# BZA #20382

# Parties in Opposition

June 23, 2021

**Drawings from B2007169**

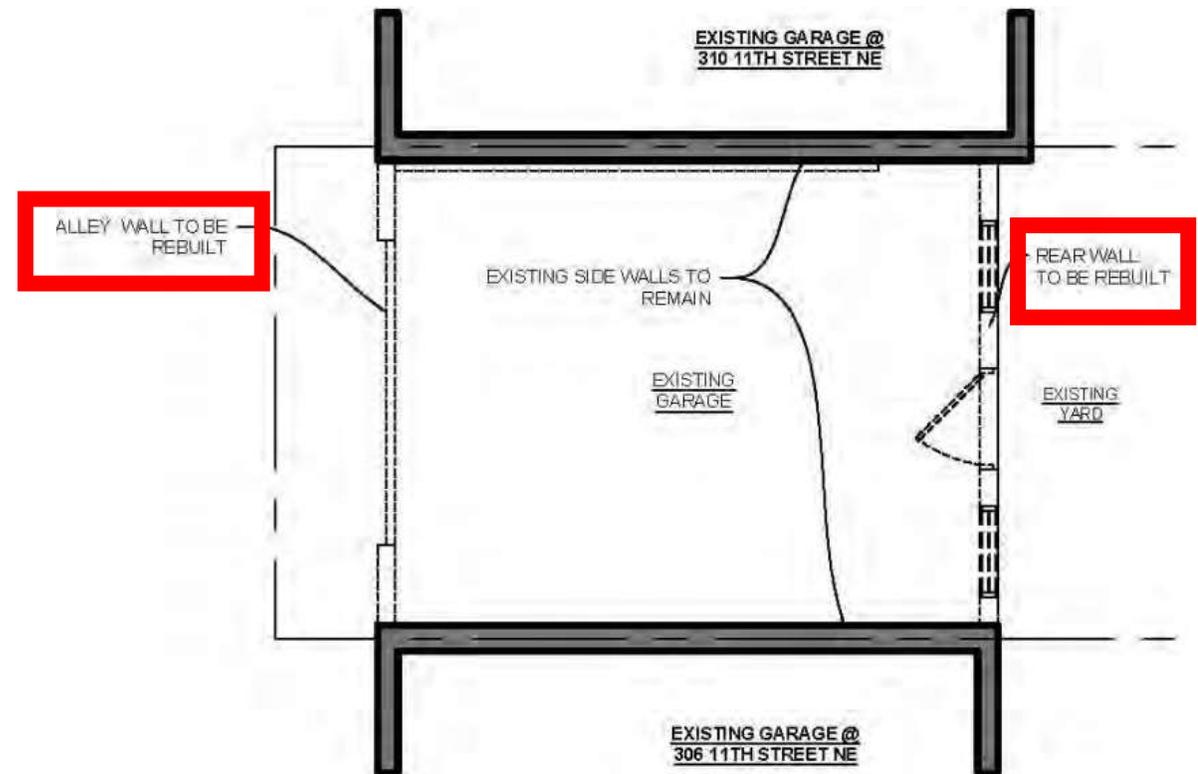
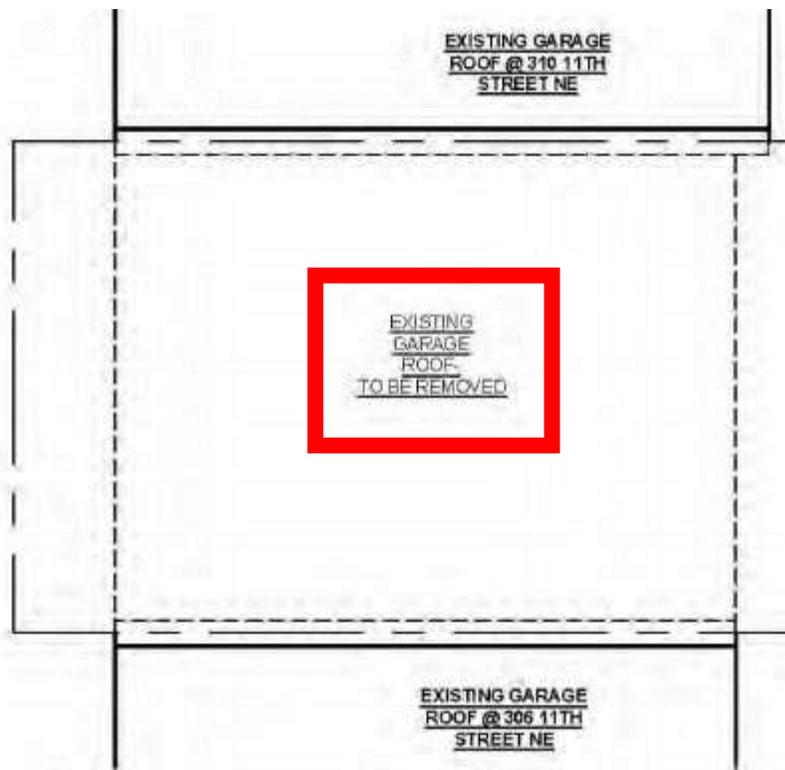
**Required rear yard will be less than 20 ft. long w/ projections (not in harmony with 11-E DCMR 306.1, 5004.2 and B 100.2)**

**Existing non-conforming garage will be demolished and replaced with a larger 2-level non-conforming garage. Doesn't Applicant need to include a request to address Subtitle C 202.2?**

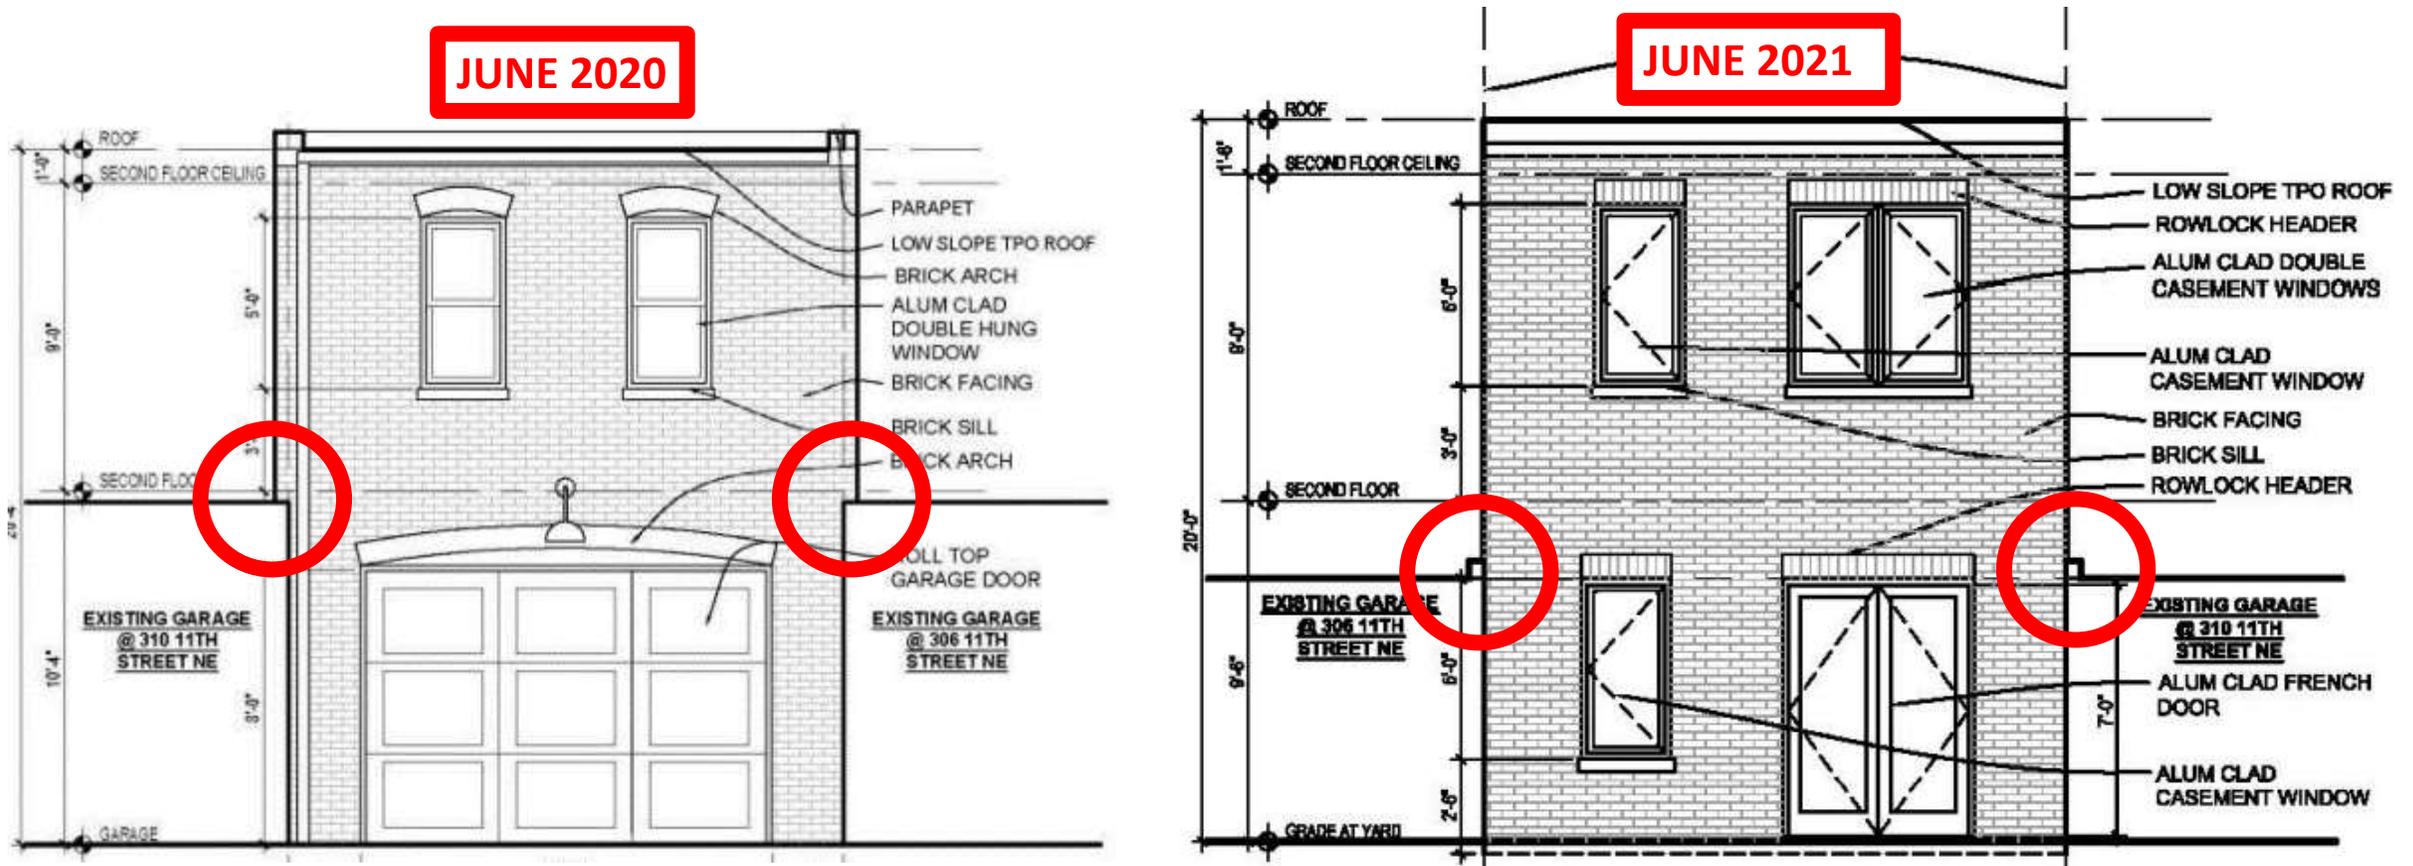
May foreclose any future use and access by adjacent properties to entire top of all party walls (garage and principal bldg.).

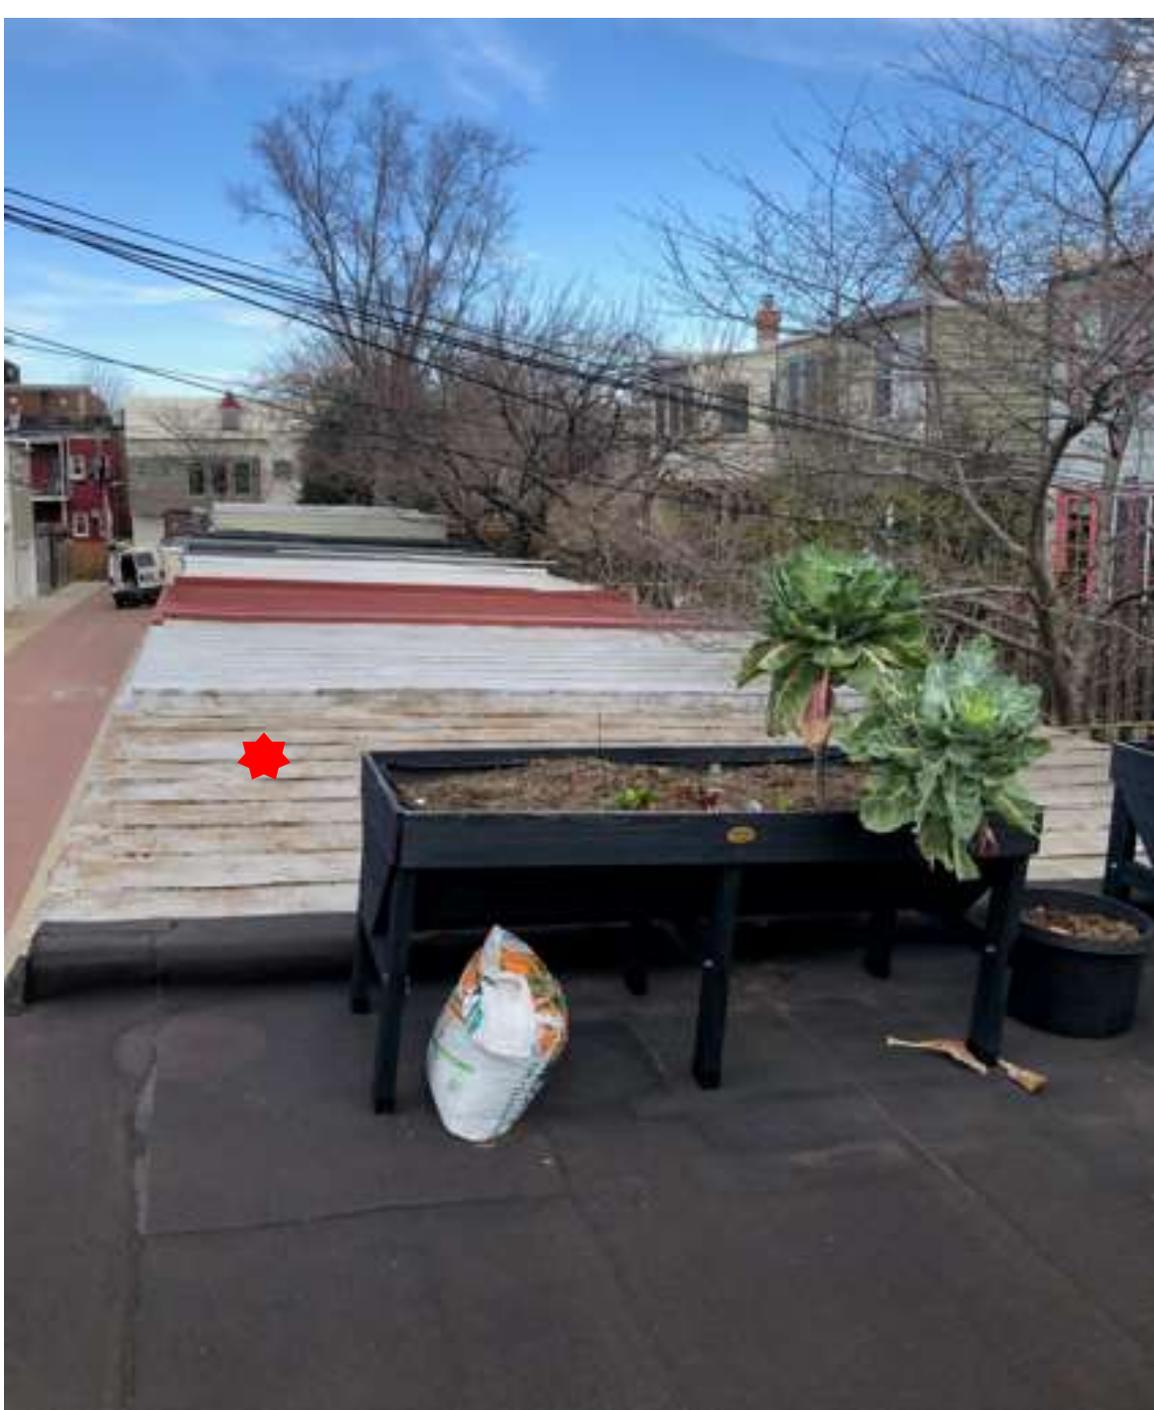
**The Project May Fatally Damage Two Protected Trees, Including A Heritage Tree** (11-C DCMR § 401 restricts damaging “Special Trees” (44 in.) and “Heritage Trees” (100 in.))

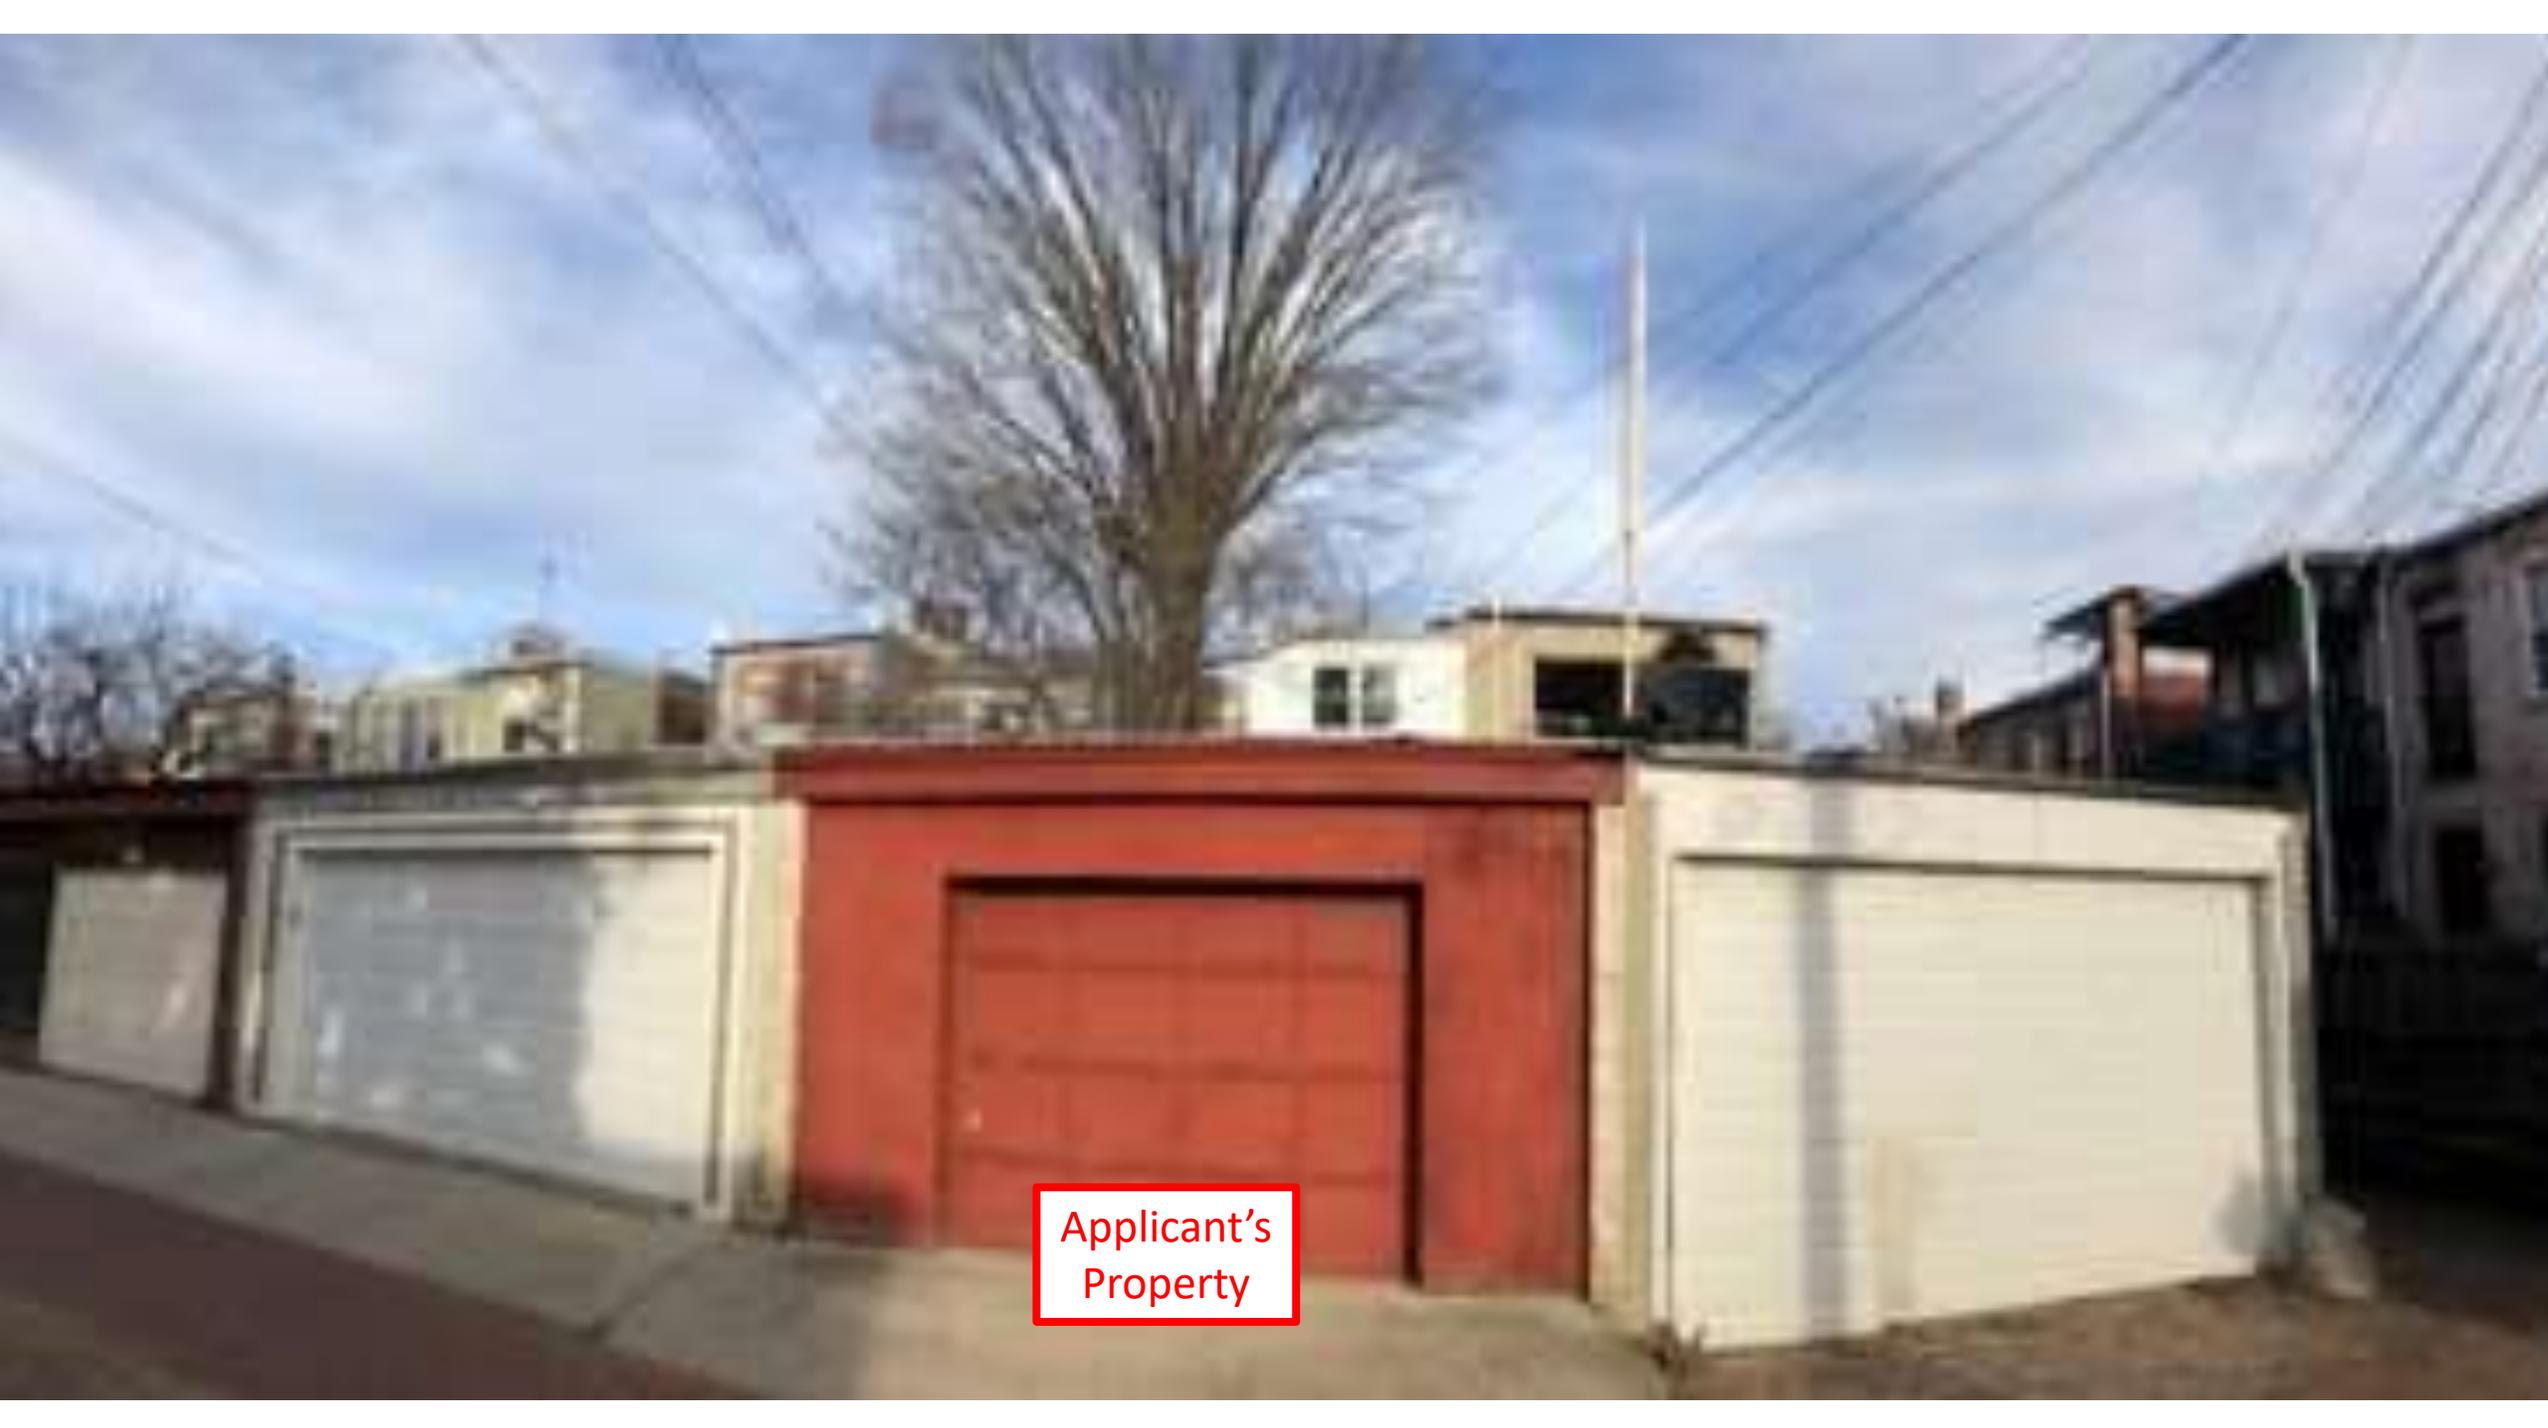
2-level garage will **SUBSTANTIALLY Visually Intrude** upon and destroy the unique, nearly uniform Character, Scale, and Pattern of the alley (11-E DCMR 5201.3)

March/September 21<sup>st</sup> 3:00 PM PROPOSED

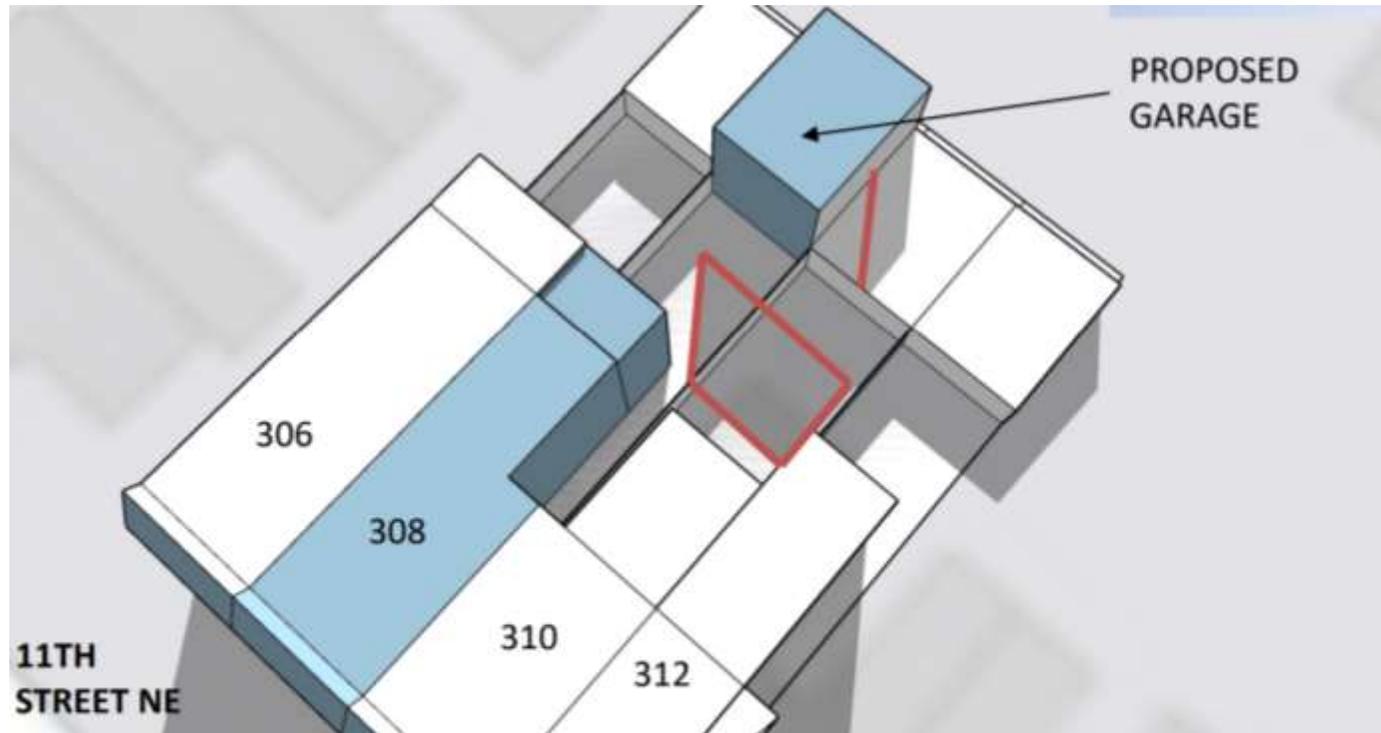
Applicant's Shade Study shows almost complete blockage of sunlight to Wilson Residence during most enjoyable/highest-use times of the year.
